addendum

addendum no. 01
date: 7/18/2017
bid date: --
project name: MCC Print Shop
project no: 17213

1 FIRST FLOOR PLAN - HVAC
M1.00 3/16" = 1'-0"

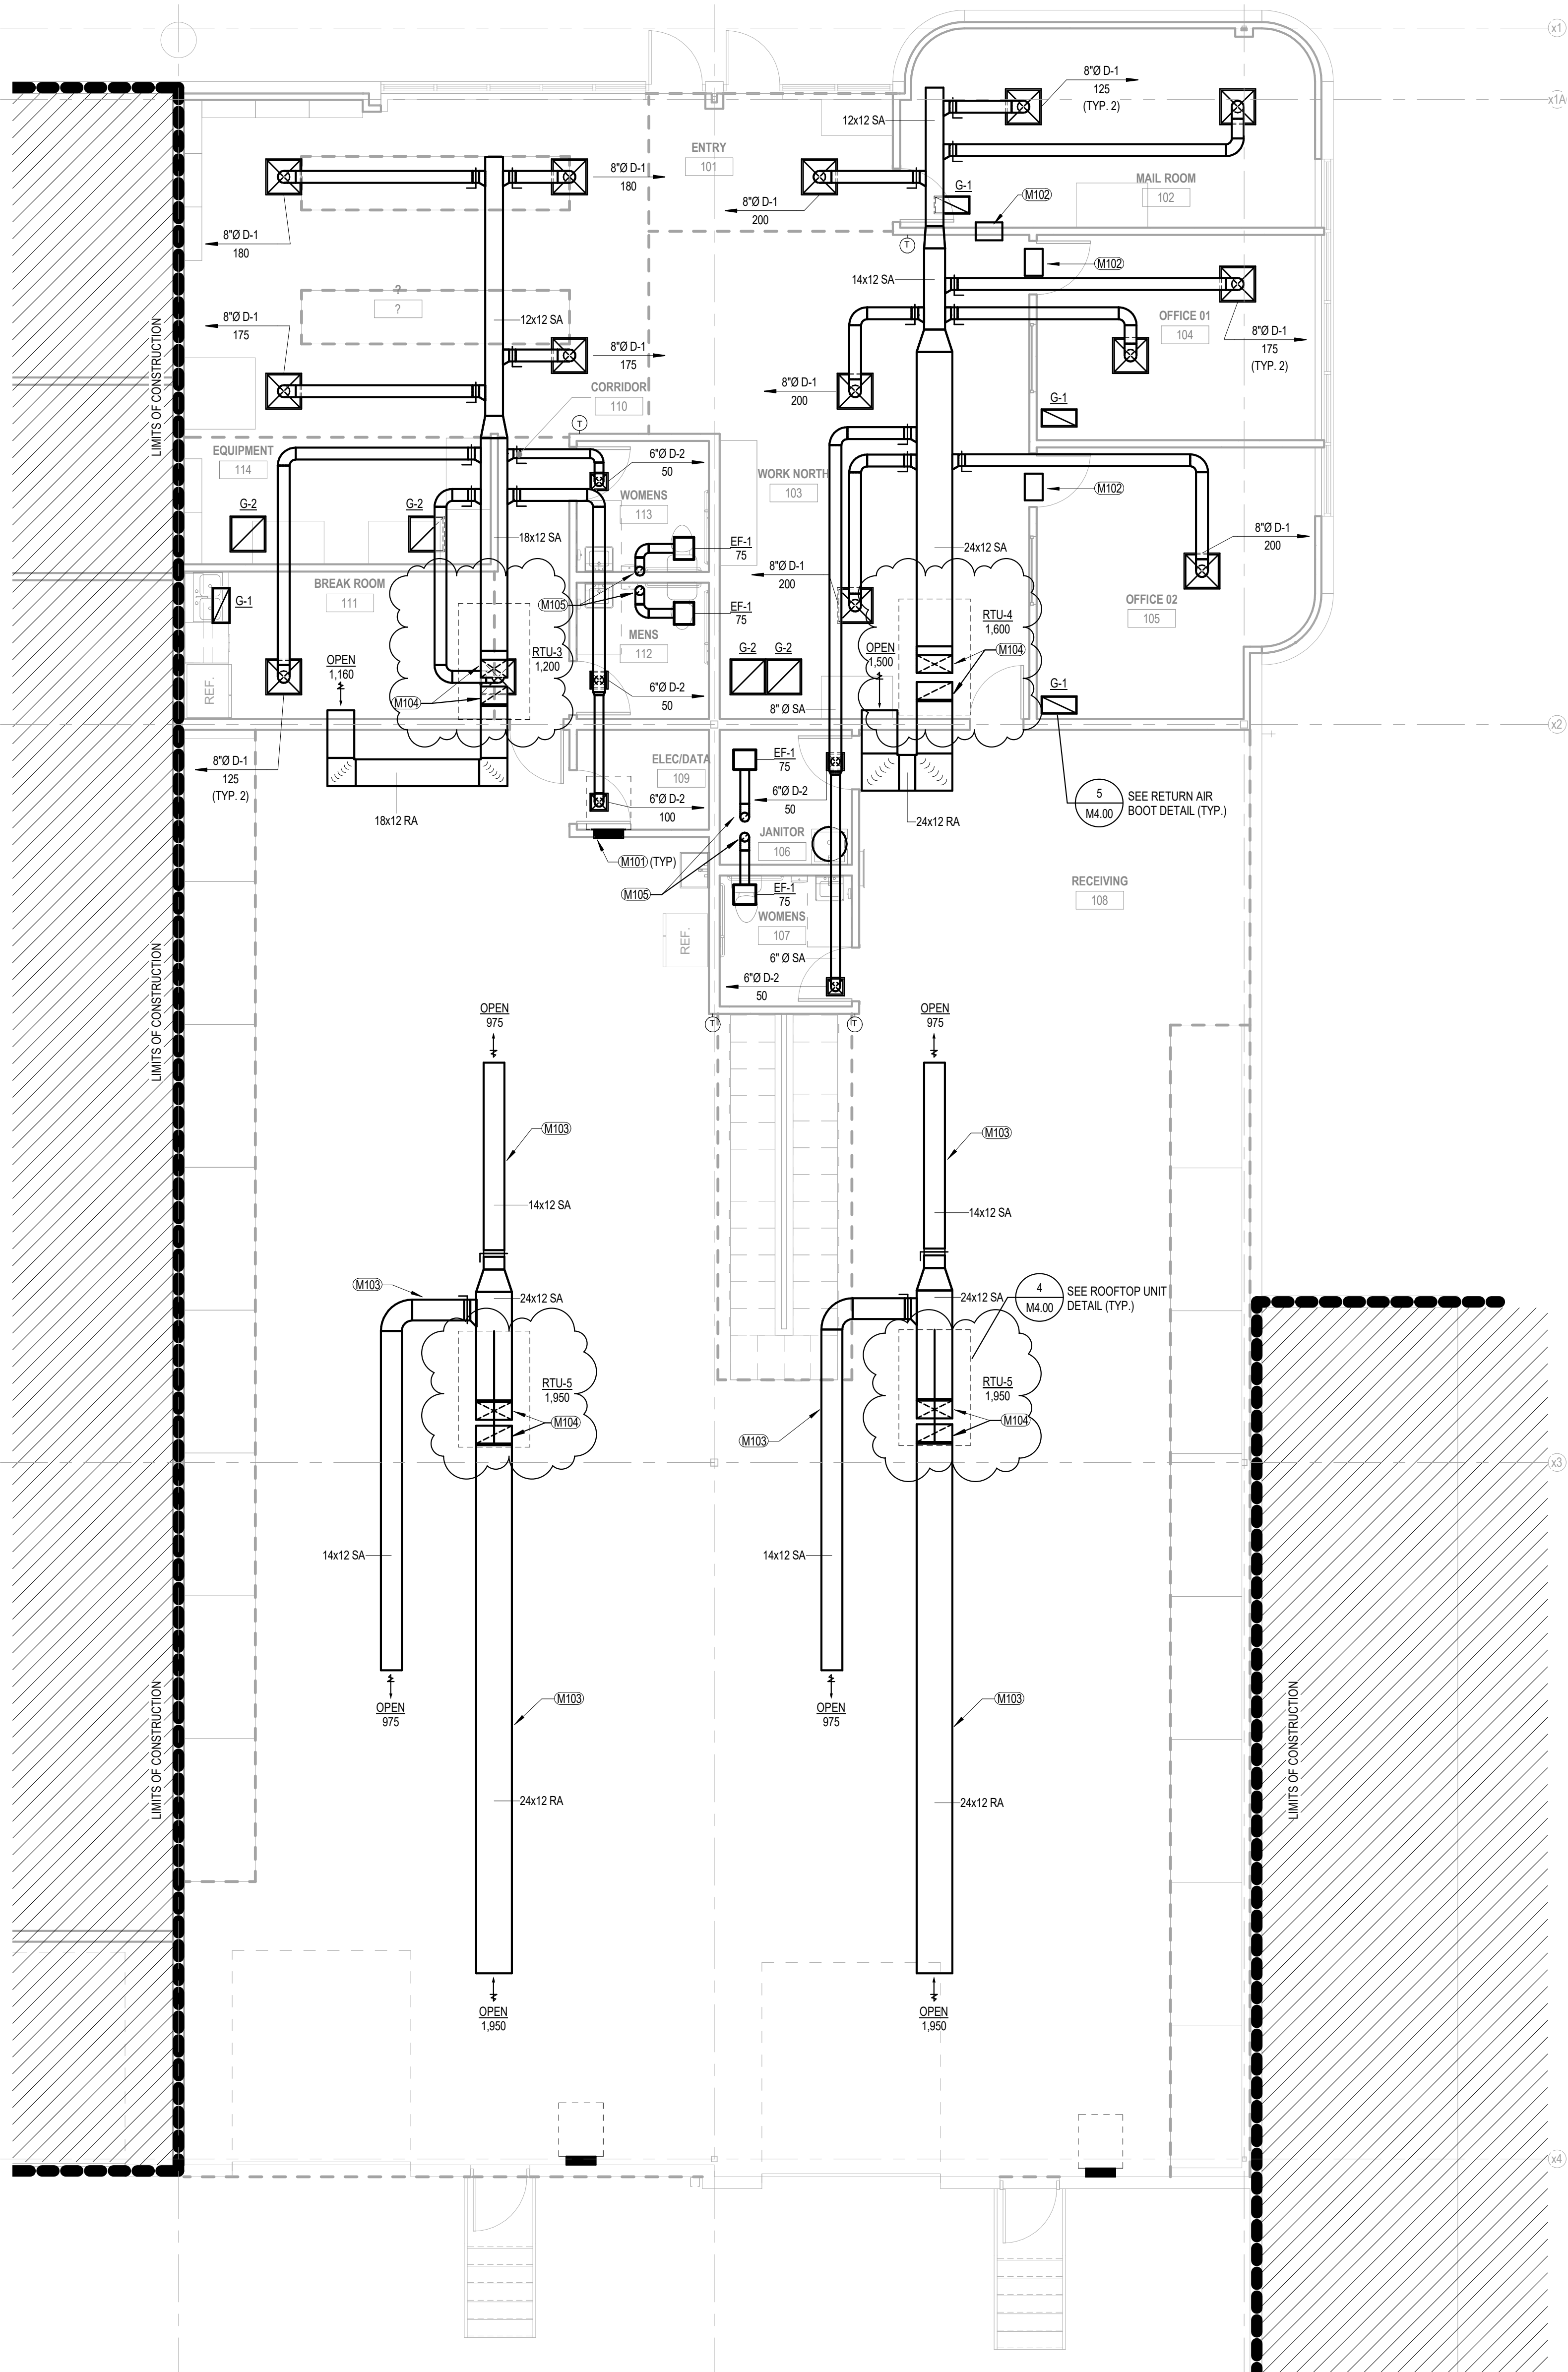
1. Sheet M1.00
 - a. Revise locations of RTUs and runouts to diffusers. See attached revised drawings.

1 FIRST FLOOR PLAN - LIGHTING
E100 3/16" = 1'-0"

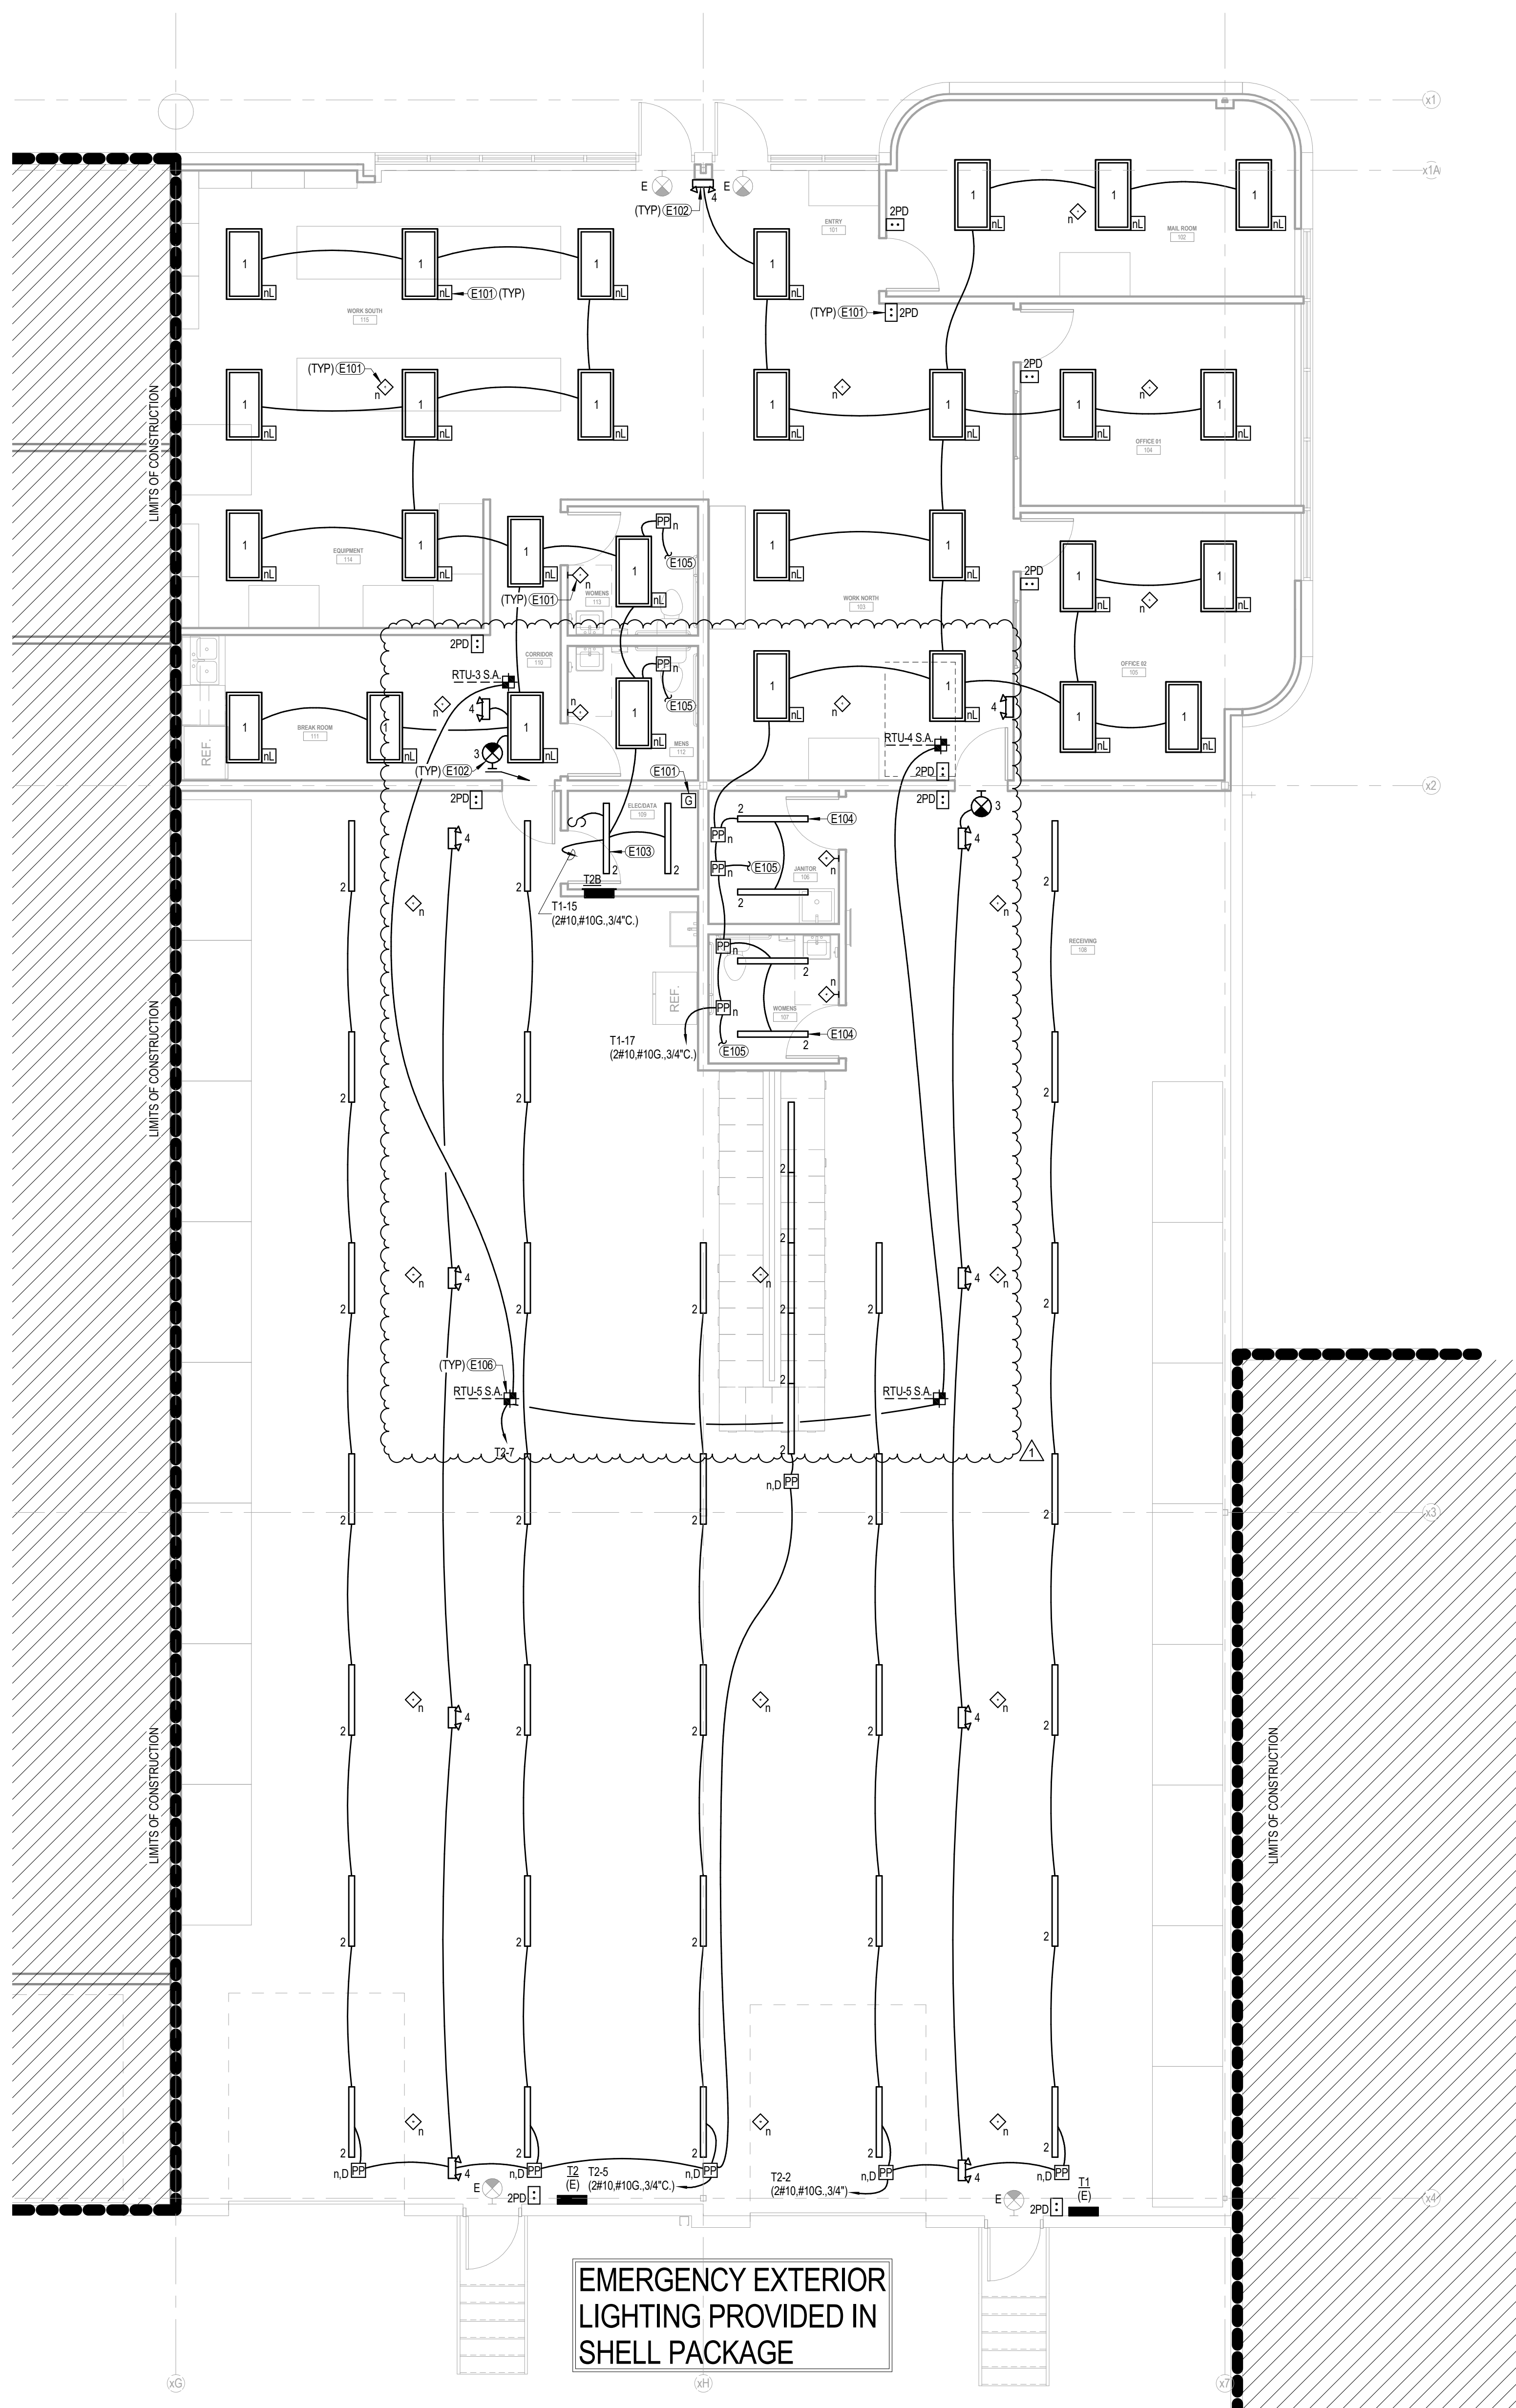
1. Sheet E1.01 – Floor Plan – Lighting
 - a. Revise locations of duct smoke detectors. See attached revised drawings.
2. Sheet E2.01 – Roof Plan – Power
 - a. Revise locations of RTUs and roof mounted receptacles. See attached revised drawings.
